SERVICE INFORMATION LETTER NO. 0090

Subject: Fuel Nozzle Air Vent Modification

Models: F-28C, 280C

Figure 1

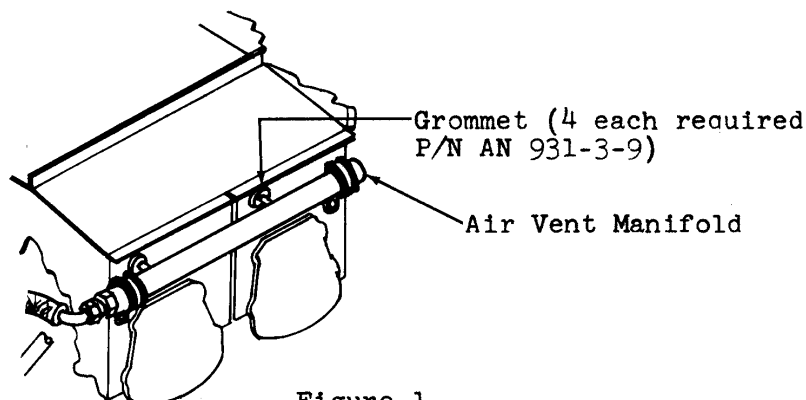
There exists the possibility of failure to the air vent manifold assembly in the area of the small tube attachment, (due to lack of cushion in the grommet where the tube passes through the engine baffle). This manifold is located on either side of the engine and just above the rocker box covers. Reference Figure 1.

In order to reduce the possibility of failure to the nozzle air vent manifold the following corrective procedure is recommended.

1. Loosen clamps that secure rubber hose from fuel nozzle and slide hose from the nozzle vent manifold tube.
2. Remove the nozzle vent manifold assembly left and right by removing screws from clamps at either end of manifold.
3. Remove the old rubber grommet from the engine baffle and enlarge the hole to .56".
4. Install new rubber grommet P/N AN931-3-9 in the enlarged hole.
5. Reinstall the air manifold assemblies and reconnect the nozzle air vent hose from fuel nozzle.
